Executive Order G-70-25-B

Relating to the Modification of the Certification of the
Atlantic Richfield Balance
Phase II Vapor Recovery System

ATLANTIC RICHFIELD COMPANY BALANCE PHASE II
VAPOR RECOVERY SYSTEM

Executive Order G-70-25-B ARCO Phase II Balance Vapor Recovery System Component List

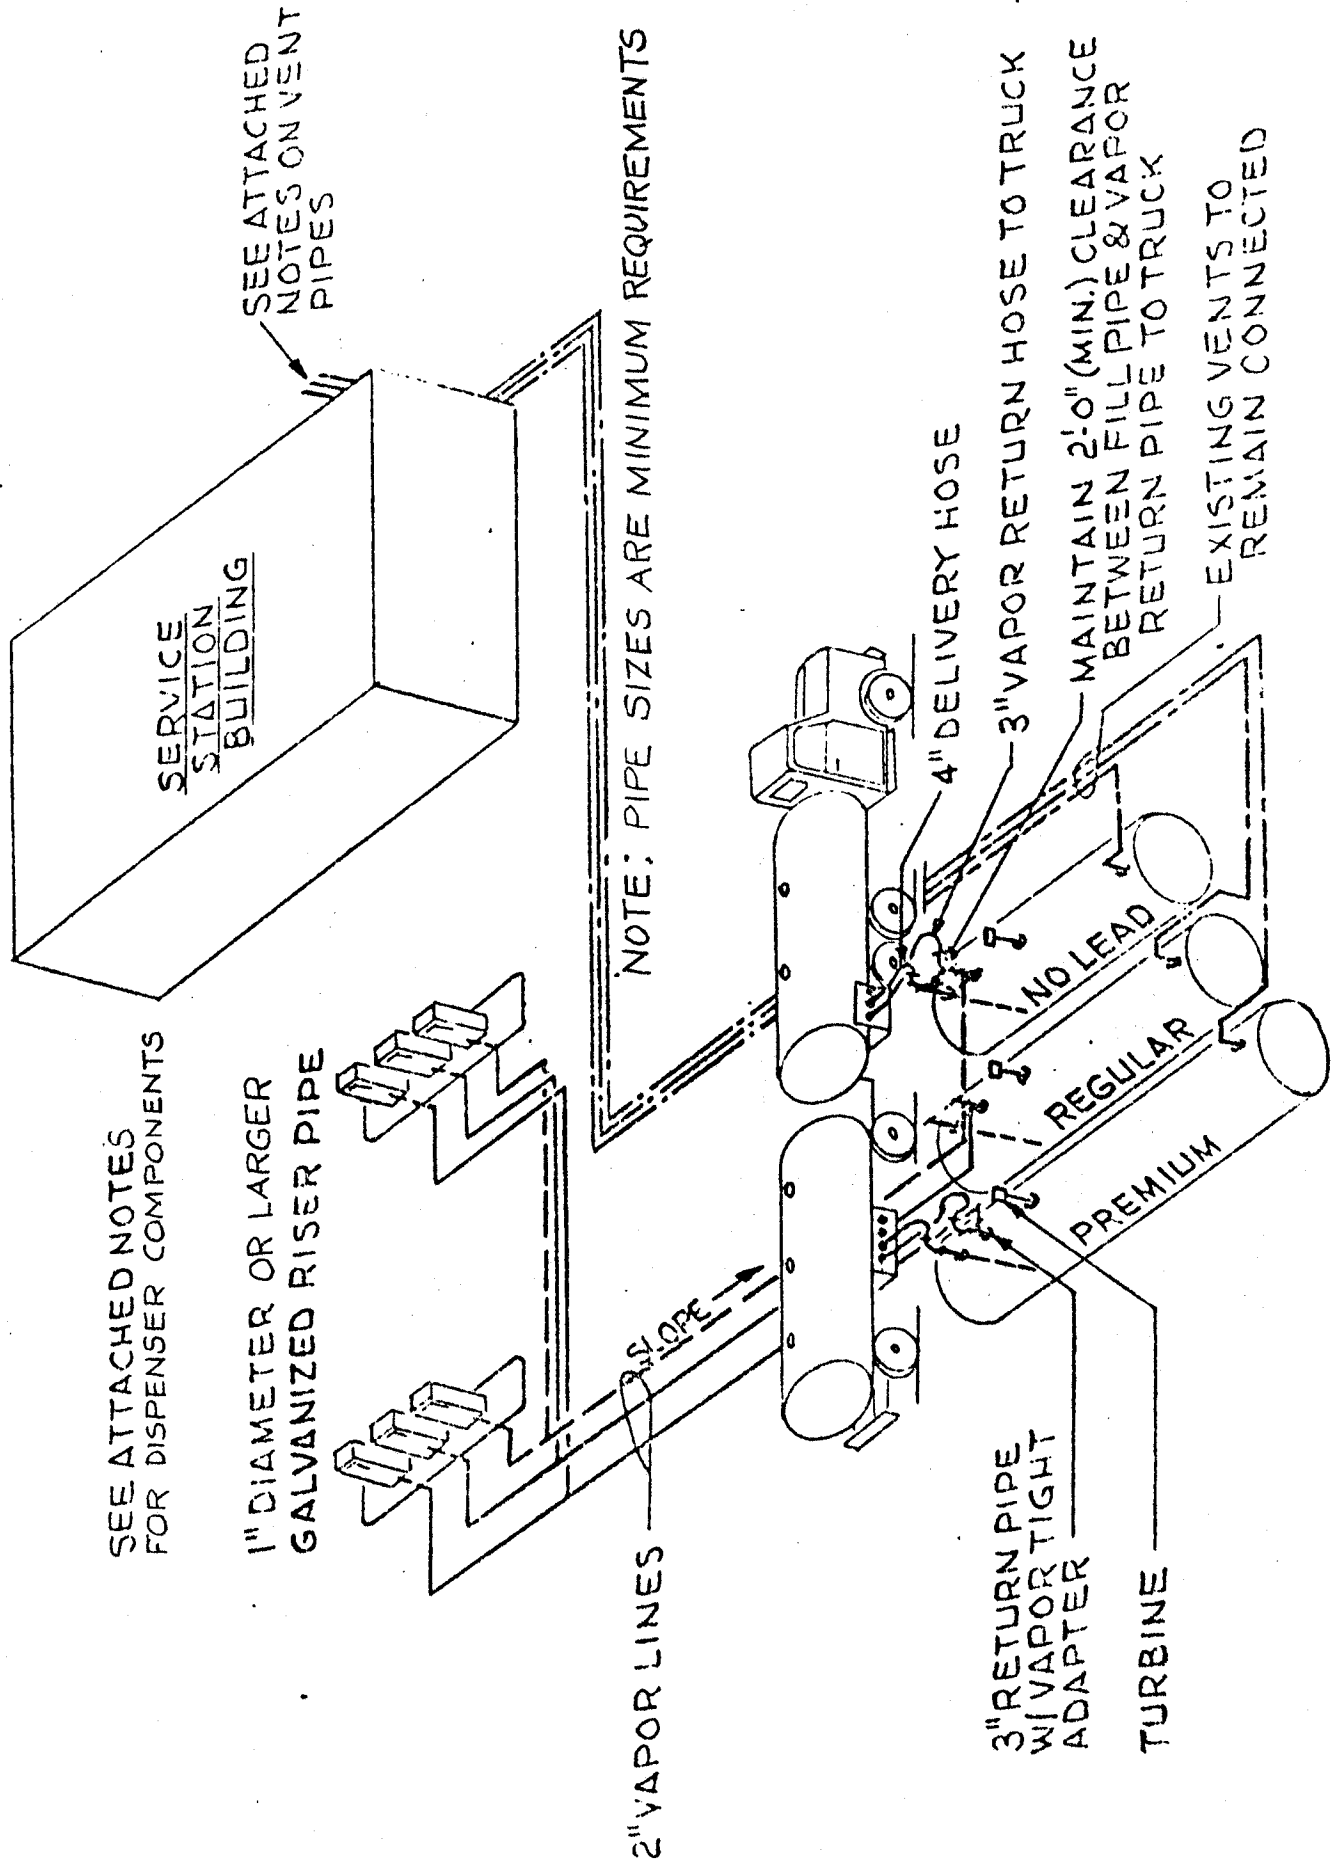
1. Require dual plane 90° swivels at the nozzle end of vapor and liquid hoses, and
2. Eliminate the previously allowed use of a single OPW 78 series recirculation trap on dual dispensers dispensing the same product from both sides.

7. State Fire Marshal approved swivels ~~(and offsets if necessary)~~ for this system shall be selected and installed on hoses to prevent hose kinking.

10. ~~On dual dispensers dispensing the same product from both sides, the vapor return lines may be connected to a single OPW 78 series recirculation trap.~~
